Attachment A

Request for Change or Approved Equal

PROPOSER#: 1	DATE: 2/22/22
PROPOSER: Creative Bus Sales	PHONE: (512) 202-2920
PROPOSER SECTION / PAGE#: Section 26.9 / p. 13	
CHANGE REQUESTED: Vans chassis (Exhibit III) vehicles are exempt from Altoona testing (unless modified in a manner not consistent with Ford QVM). A 5-year / 100,000-mile test is not available for this class/category of vehicles.	
AGENCY RESPONSE	
Reviewed By: T. Kuczynski	Date: 4 March 2022
Approved <input checked="" type="checkbox"/>	Denied <input type="checkbox"/>
	See Comment Below <input type="checkbox"/>
COMMENT:	
Revised response: Based on the documentation provided for the proposed vehicle type in this asset class, Altoona testing is exempt.

40 – ambulatory passengers with two wheelchair positions occupied, three 3-step foldaways over those positions

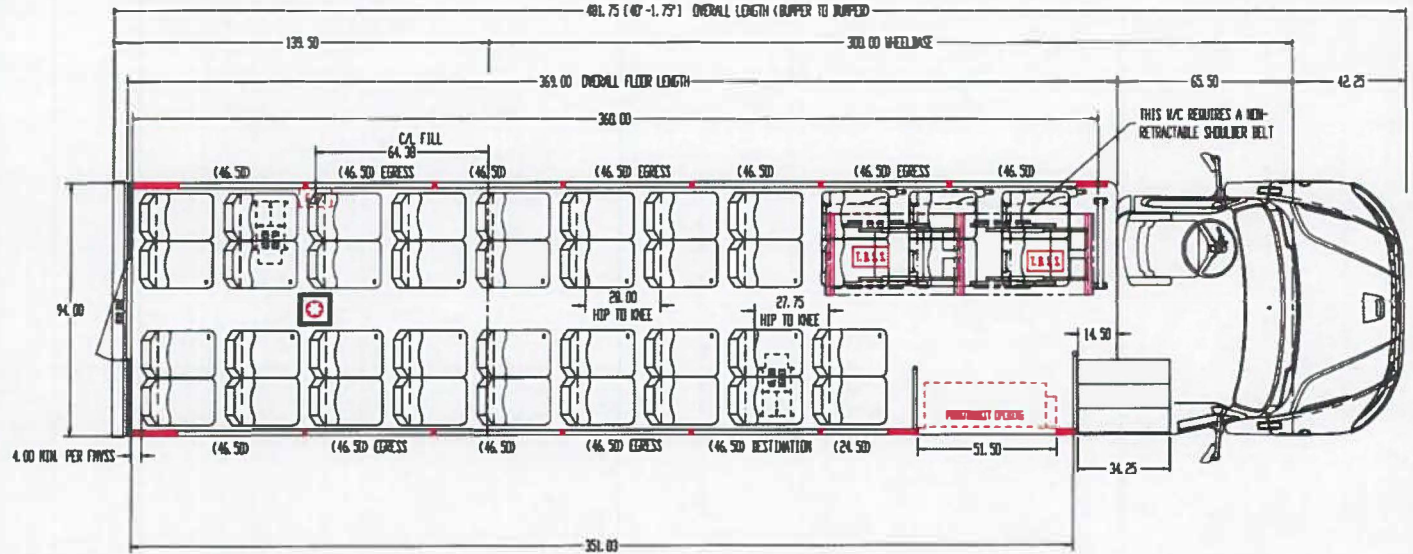
Texas Bus Sale respectfully requests the acceptance of a Champion Defender Champion Defender manufactured by Forest River with the floorplan shown below.

RESPONSE T. Kuczynski 25 Feb 2022

32 – ambulatory passengers with two wheelchair positions occupied, four 3-step foldaways over those positions

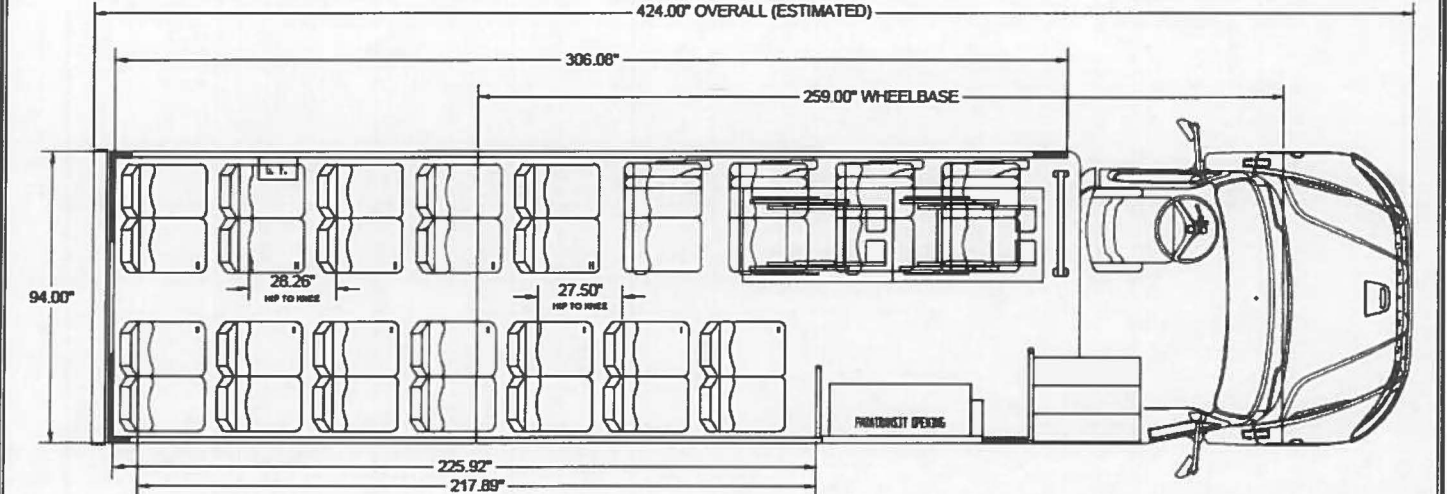
Texas Bus Sale respectfully requests the acceptance of a Champion Defender Champion Defender manufactured by Forest River with the floorplan shown below.

RESPONSE T. Kuczynski 25 Feb 2022
